# Final Environmental Impact Report

## **WATERFRONT PARK AND HOTEL**

## **YOUTH HOSTEL PROJECT**

**SUBJECT:** ADDENDUM TO FINAL EIR: WATERFRONT PARK AND HOTEL AND YOUTH HOSTEL PROJECT (#ENV92-0107)

**FIGURE VIA-1  
EXISTING FRIDAY PM PEAK HOUR VOLUMES**

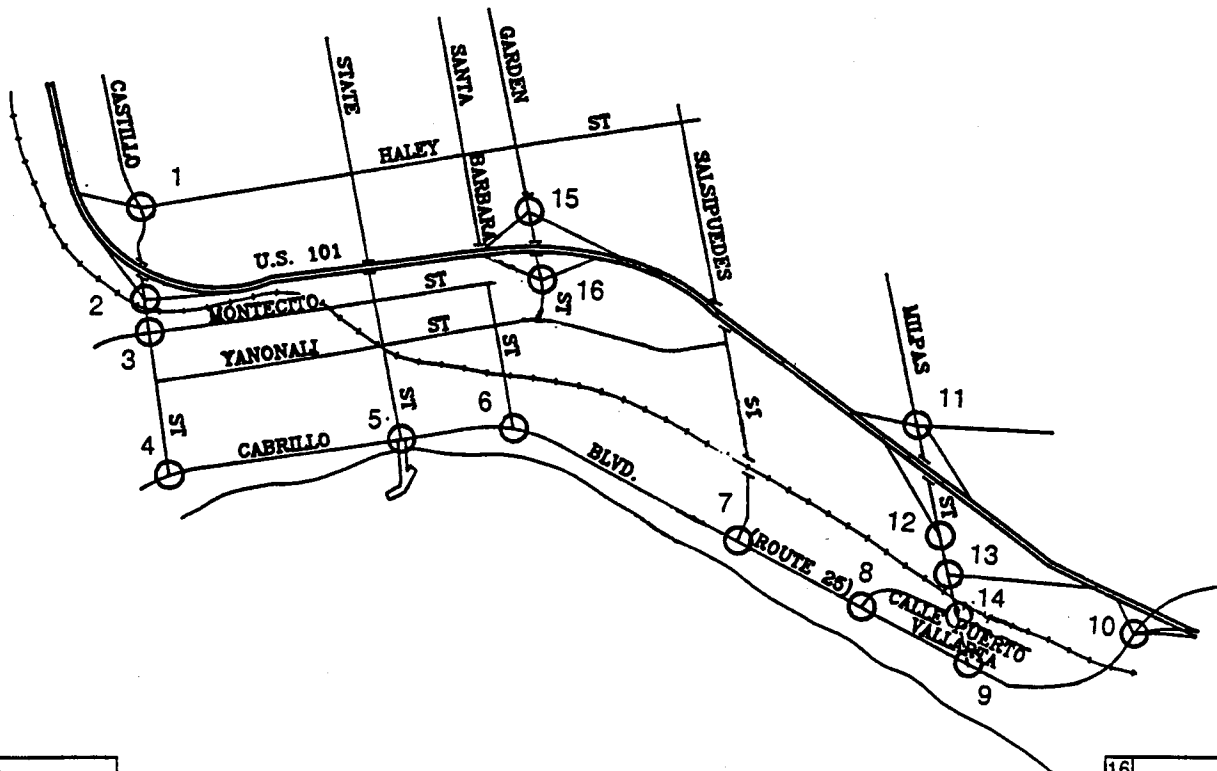
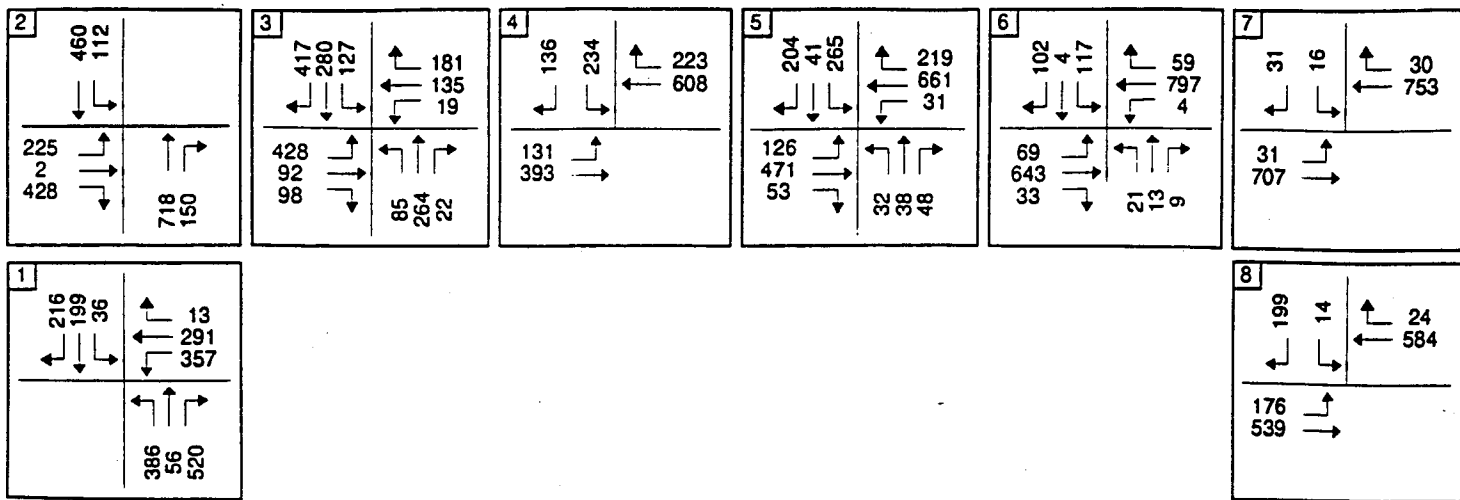
2-2 2) Chapter VI.A, Page 75, Figure VIA-1. This figure shows 784 vehicles travelling westbound on Cabrillo Blvd., just west of Salsipuedes (see node #7,  $753+31=784$ ), and 860 vehicles arriving at Santa Barbara St. (see node #6,  $59+797+4=860$ ) during the Friday PM peak hour. Since there are no roads or parking lots between these points on Cabrillo Blvd., please provide an explanation for the additional 76 vehicles.

**FIGURE VIA-8**  
**EXISTING + CUM. + PROJECT WITH SALSIPUEDES STREET**  
**EXTENSION FRIDAY PM PEAK HOUR VOLUMES**

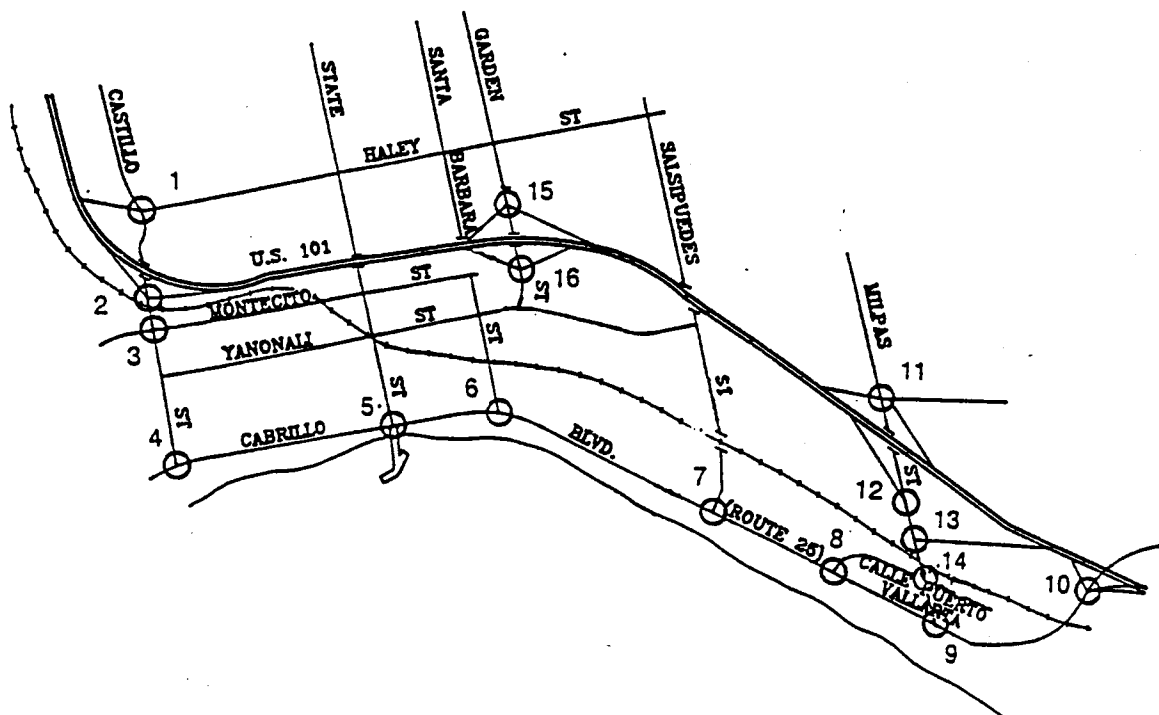
1-11	96	In addition to Figure VIA-8, a figure is needed that shows the change in traffic volumes (+ or -) with the addition of the Garden and Salsipuedes extensions.
1-12	98	Table VIA-7, add a footnote that indicates that the bold text identifies intersections significantly impacted.
